(PR-1) *PLAN REVISION I ESC PHASE I CONSTRUCTION SEQUENCE*
(FOR CONDITIONS AS OF AUGUST, 2019)

PHASE I EROSION & SEDIMENT CONTROL PLAN

RIDGE AT FAIRWAY FOREST SECTION 3

NO.	DATE	REVISIONS DESCRIPTION
1	8/20/2019	ADDED LOTS 13A & 13B, "TYPE "A" & "B" SWALE & UPDATE ESC PLAN
2		
3		
4		
5

ESC PHASE I

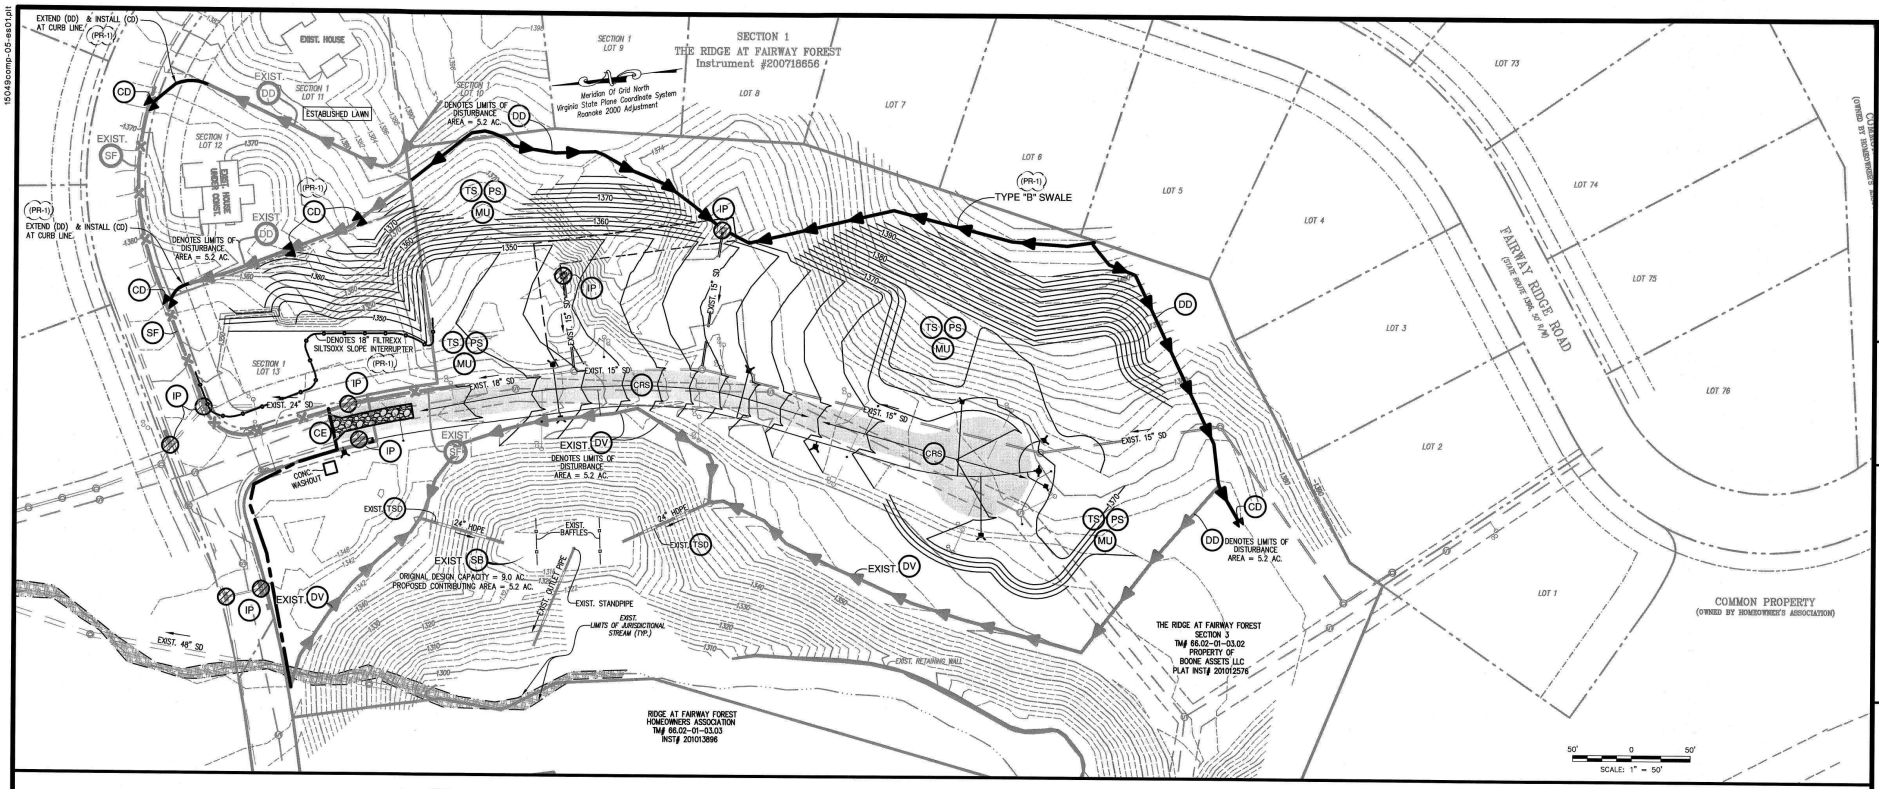
1. EXTEND EXIST. (DD) BETWEEN SECTION 1 LOTS 11 & 12 AND INSTALL (CD) AT CURB LINE.
2. INSTALL (CD) ON EXIST. (DD) BETWEEN SECTION 1 LOTS 12 & 13 AS SHOWN ON THIS PLAN.
3. GRADE SLOPE ON SECTION 1 LOT 13 AS SHOWN ON THIS PLAN. DENUDED AREAS SHALL BE STABILIZED IN ACCORDANCE WITH MIN. STD. 3.31 "TS", 3.32 "PS", & 3.35 "MU". ALL SLOPES GREATER THAN 3:1 SHALL BE STABILIZED PER MIN. STD. 3.36 "BM".
4. INSTALL 18" FILTREXX SILTSOXX SLOPE INTERRUPTER ON SECTION 1 LOT 13 AS SHOWN ON THIS PLAN.
